# TECHNICAL BULLETIN

[Issue No.] T09-0008-B

[Title] Production Discontinuation of Ethernet Interface Modules  
(MELSEC-QnA/A Series)

[Relevant Models] AJ71QE71, AJ71QE71-B5, A1SJ71QE71-B2, A1SJ71QE71-B5,  
AJ71E71-S3, A1SJ71E71-B2-S3, A1SJ71E71-B5-S3

The following diagram shows the AJ71QE71N-B5T and AJ71E71N-B2. The dimensions of the AJ71QE71N-B5T are the same as AJ71E71N-B5T. Also, the AJ71QE71N-B2 is the same as AJ71E71N-B2.

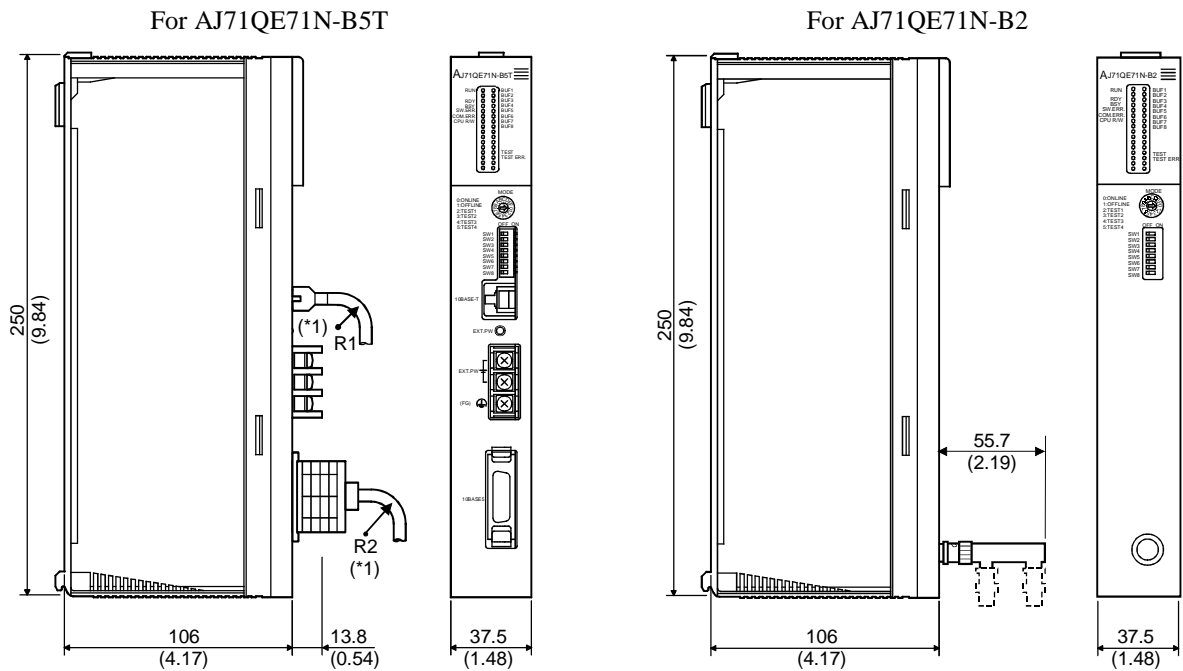
- 3) Replace the old version models with the new version models, while paying attention to the following differences in the external appearances.
  - The 10BASE-T interface has been added (AJ71QE71N-B5T, A1SJ71QE71N-B5T).

- The orientation of the 10BASE5 interface connectors has been rotated by a 180° (A1SJ71QE71N-B5T).
  - The connector position for the 10BASE2 interface has been moved from the bottom to front side (AJ71QE71N-B2, A1SJ71QE71N-B2).

- The layout of display LEDs has been changed (AJ71QE71N-B2, AJ71QE71N-B5T, A1SJ71QE71N-B2, A1SJ71QE71N-B5T).
  - The position of the communication condition setup switch has been moved from the front to left side (A1SJ71QE71N-B5T).

- The external power supply terminals (for supplying power to the transceiver) do not include an FG terminal (A1SJ71QE71N-B5T).

The following diagram shows the A1SJ71QE71N-B5T and A1SJ71QE71N-B2. The dimensions of A1SJ71QE71N-B5T are the same as A1SJ71E71N-B5T. Also, A1SJ71QE71N-B2 is the same as A1SJ71E71N-B2.

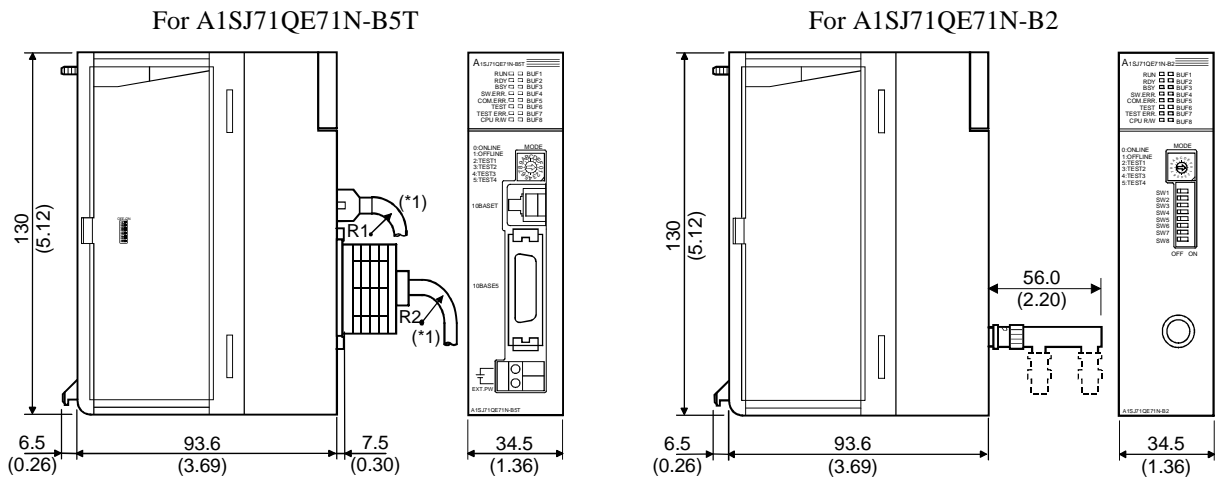
\*1: The bending radius near the connectors (reference value: R1, R2) should be four times larger or more than the cable's external diameter when connecting the communication cable.
